National Transportation Safety Board

Safety Recommendation

Date: October 7, 1998

In reply refer to: A-98-87

Figure 2. Cross-section of the JT8D fan and LPC and view of an LPC rear tierod

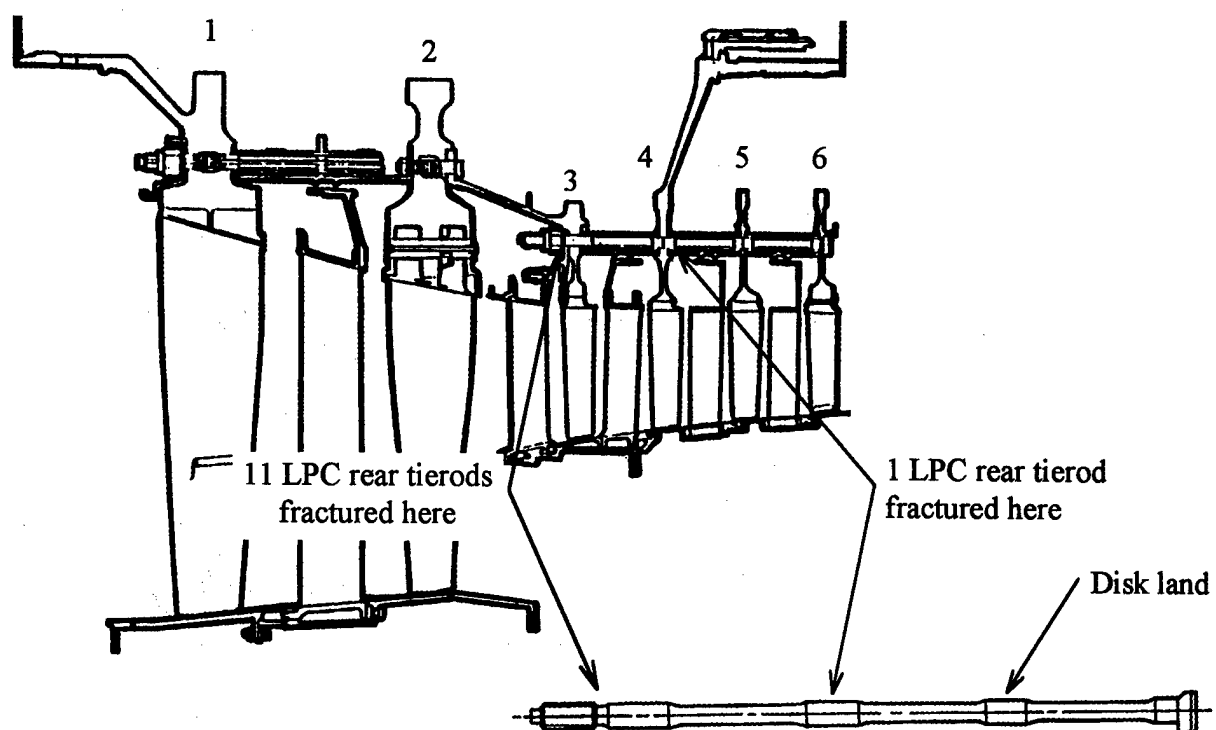
tierod had surface corrosion, suggesting that the tierod had been broken for some time. Because of overstress, the 11 remaining LPC rear tierods were fractured at their forward ends between the 3rd stage compressor disk lands and the tierod nut threads. All six of the recovered tierod nuts and ends had numerous pockmarks on one side, and the tierod ends were bent away from the pockmarks. The pockmarks and bending damage suggest that after the initial tierod fractured and was liberated from the compressor, it tumbled around in the cavity at the front of the LPC and impacted the other tierod nuts and ends until they eventually fractured, causing the compressor to separate between the 3rd and 4th stage rotors and the engine to fail. Eleven equally spaced fan exit vanes had the imprints of the tierod nuts on the leading edge, indicating that the 11 remaining tierods fractured simultaneously when the engine failed.

The Safety Board's examination of the LPC rear tierod with the corroded fracture face revealed that a fatigue fracture originated from a small area of galling⁶ on the 4th stage compressor disk land. On July 7, 1982, as a result of 33 LPC rear tierod fractures at the 3rd and 4th stage disk land locations that caused damage in JT8D engines, P&W issued Service Bulletin (SB) 5407.⁷
